REMARKS

U.S. APPLICATION NO. 09/242,822
AMENDMENT UNDER 37 C.F.R. § 1.111

Fig. 1

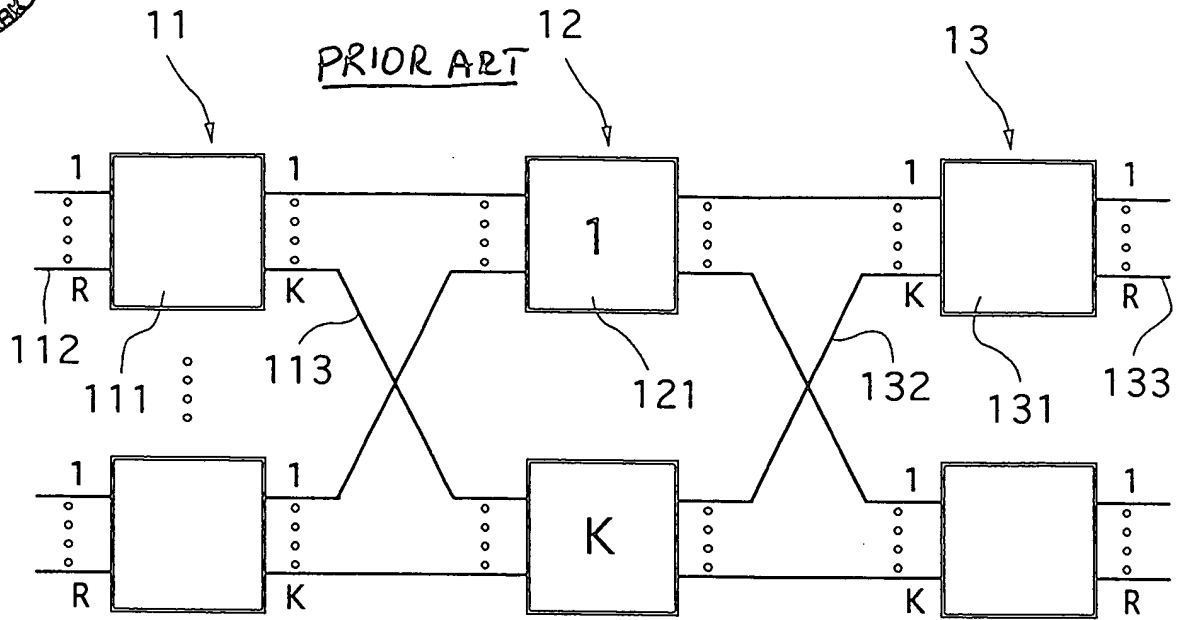
The drawings are objected to for the reasons set forth at page 2 of the Office Action. Applicant is submitting herewith proposed drawing changes to Figs. 1 and 4A, labeling these figures as "Prior Art." Applicant is also amending the Specification to clarify the description of Figs. 4A and 4B.

With respect to Fig. 4B, Applicant disagrees that this figure discloses only that which was in the prior art. To the contrary, Fig. 4B is not prior art, since the switching architecture is different from the Clos network illustrated in Fig. 1. In particular, Fig. 4B is a specific example

PRIOR ART
